ADDENDUM 1

August 3, 2023

Carthage Flats
7020 Vine Street
Cincinnati, OH 45216

Emboss Design (formerly PCA)
906 Monmouth Street
Newport, KY 41071

3. AS100 ARCHITECTURAL SITE PLAN

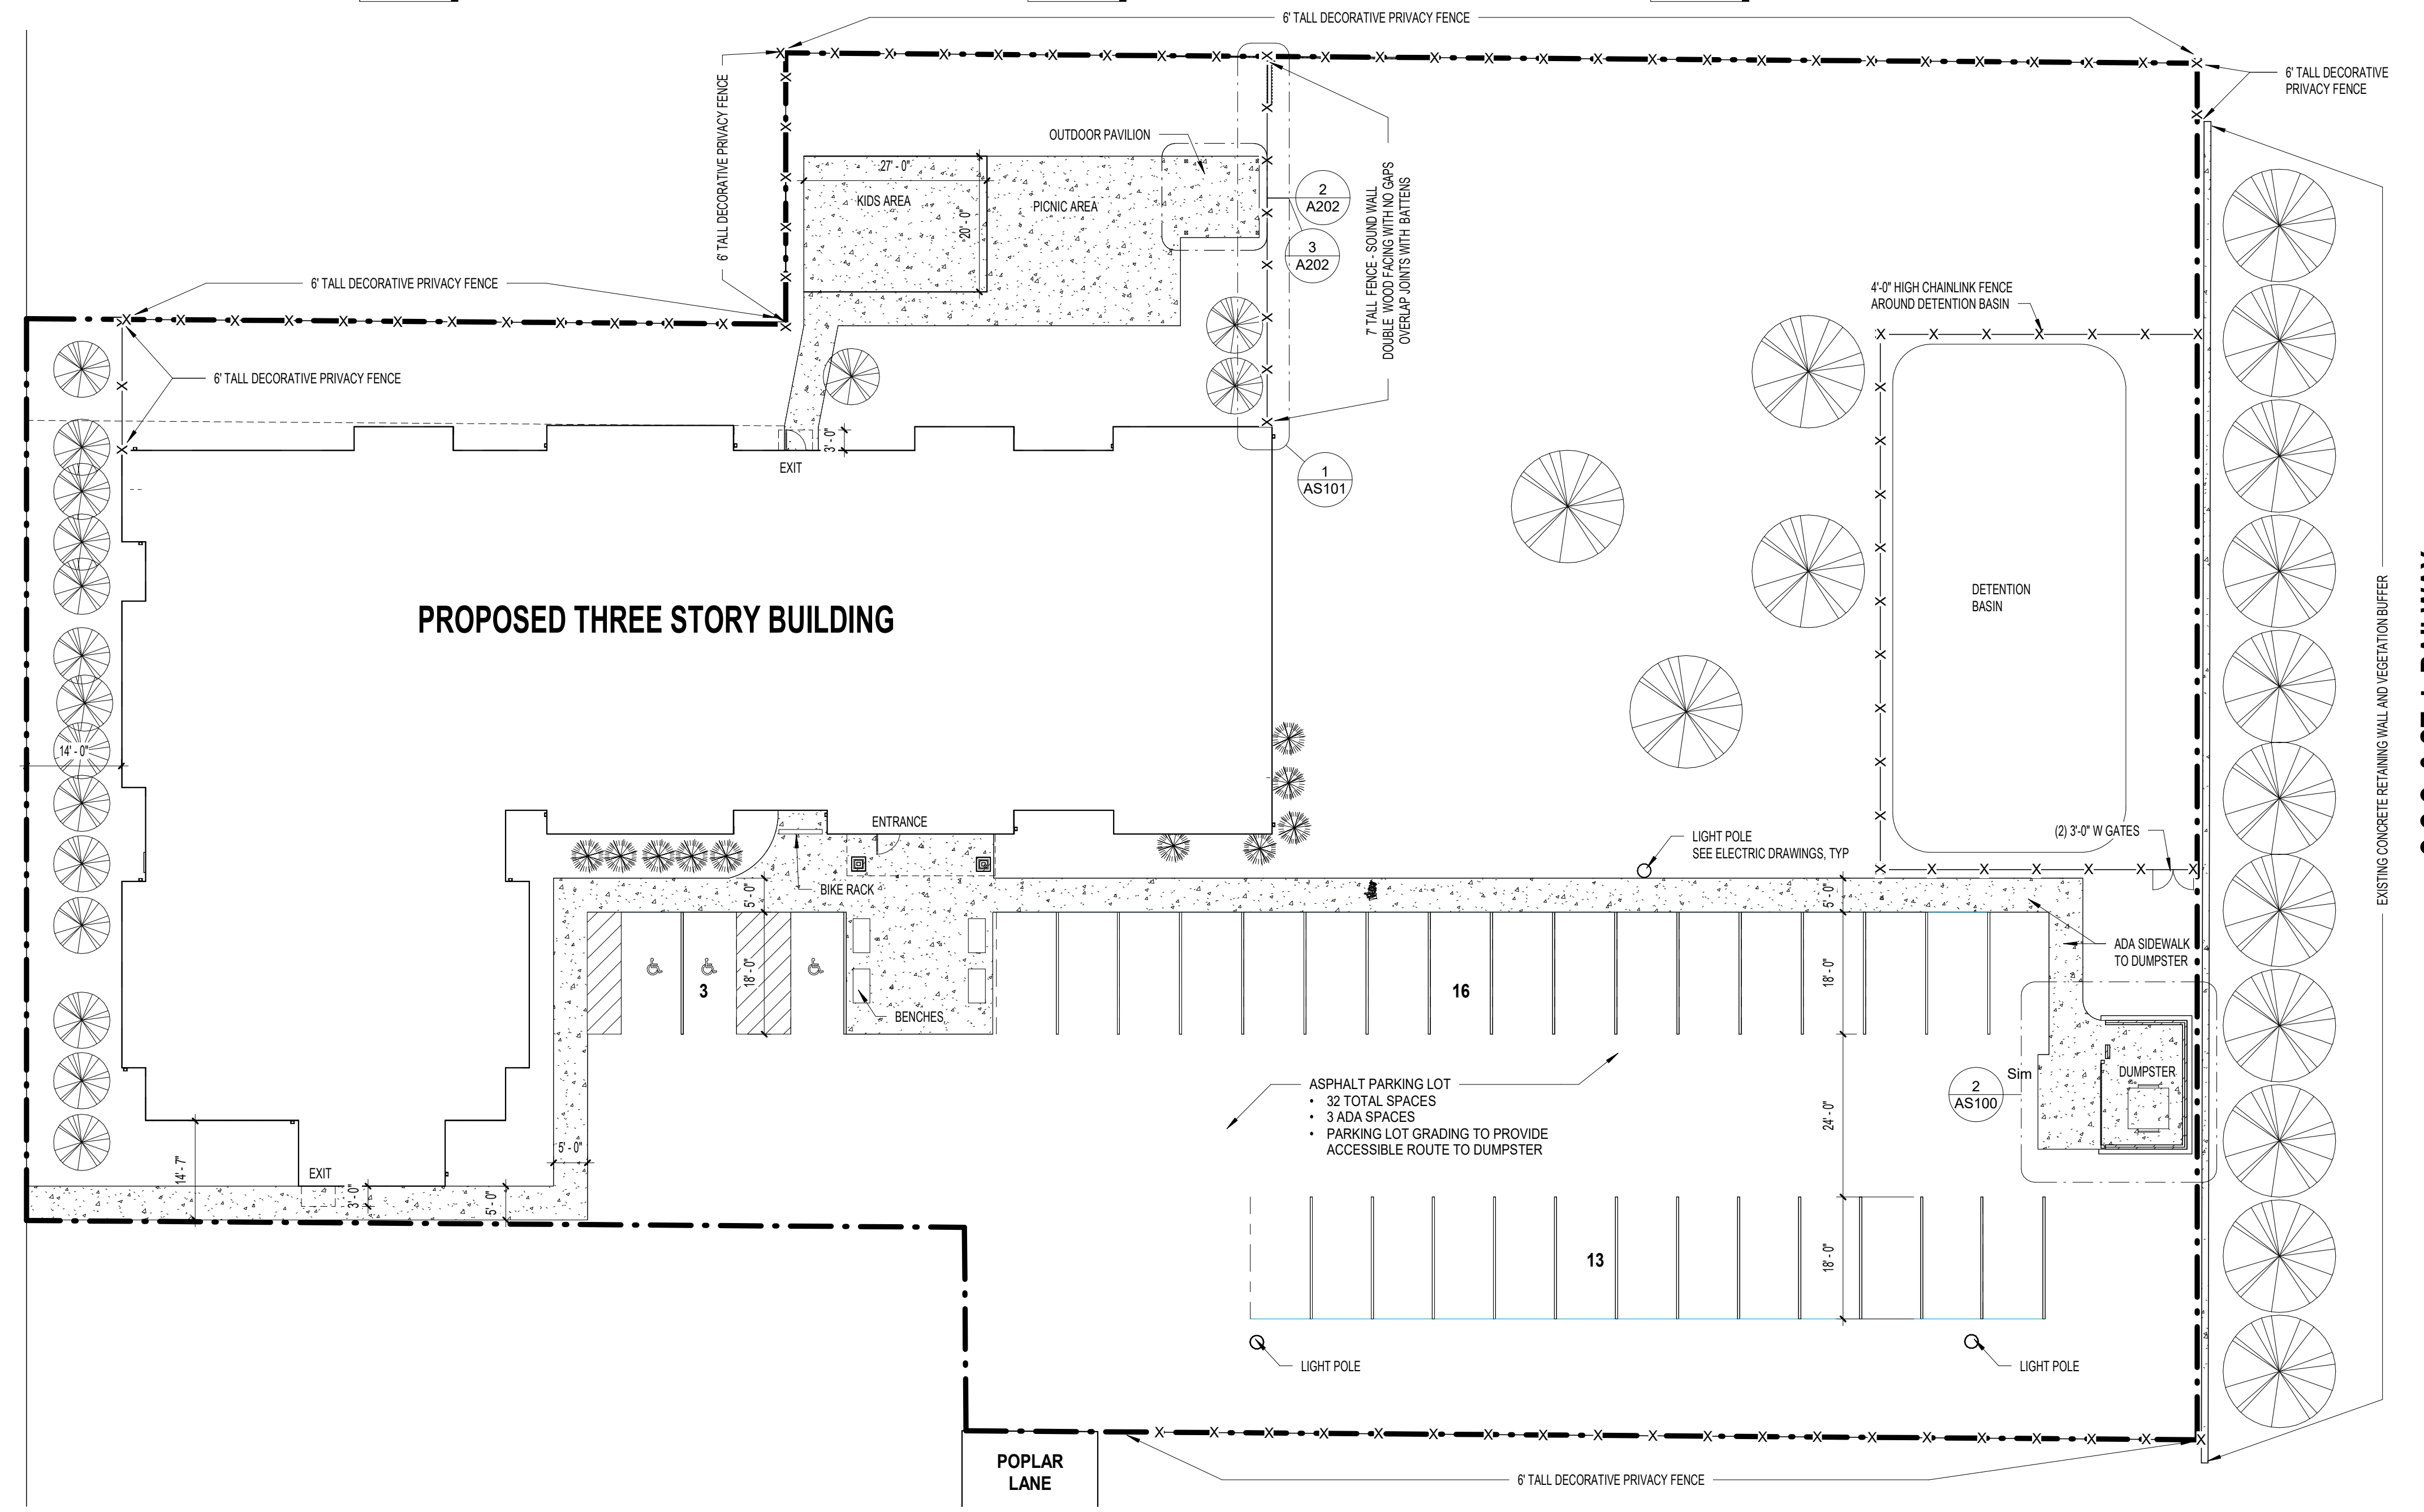
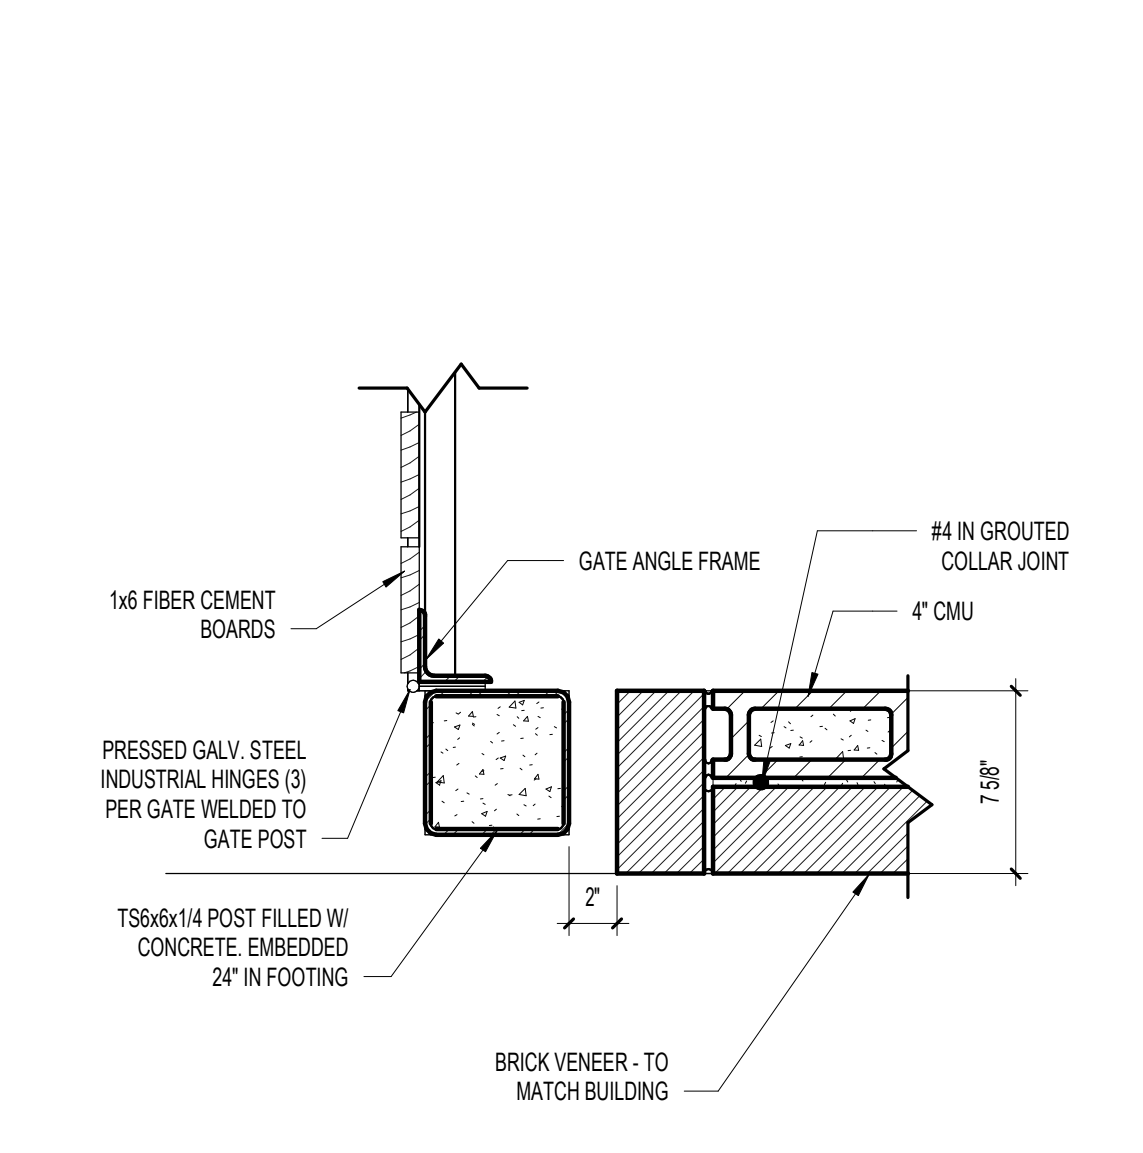
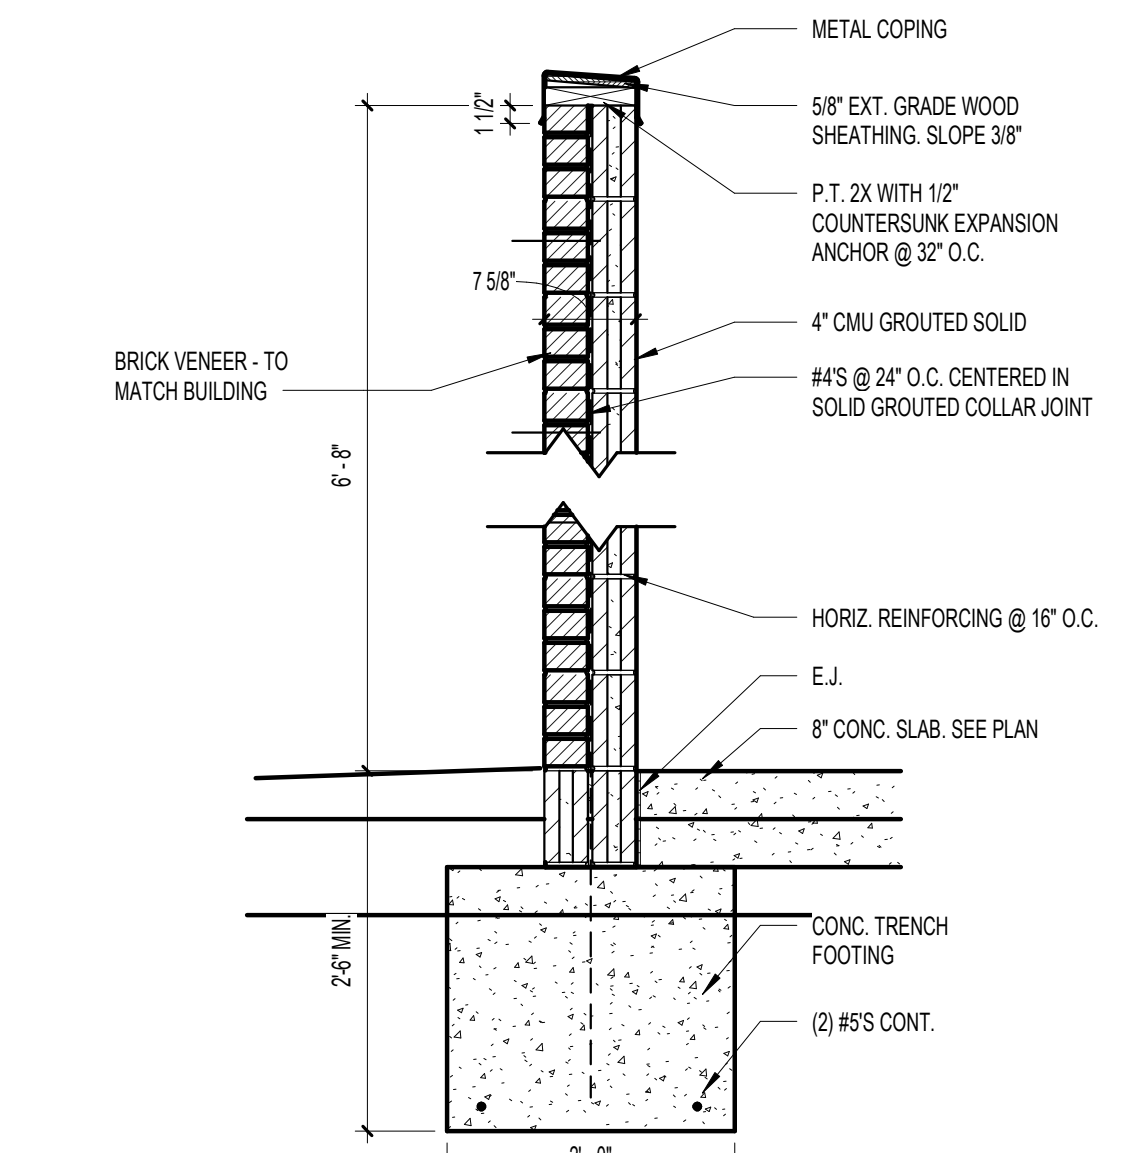
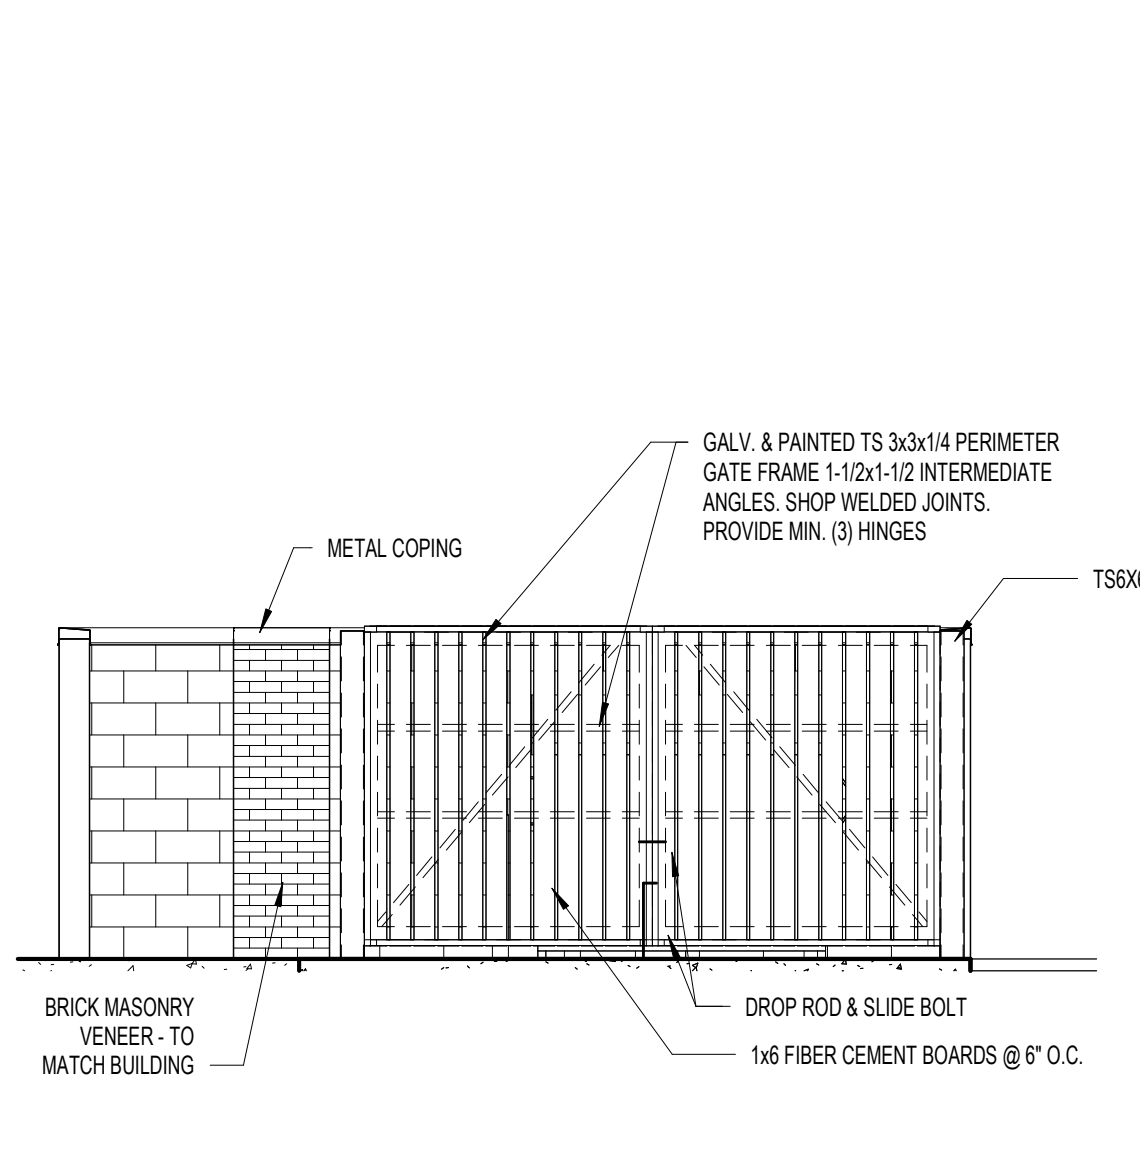
- Revised shape of the kids area and picnic area.
- Revised location of outdoor pavilion.
- Added 7' tall fence – sound wall.
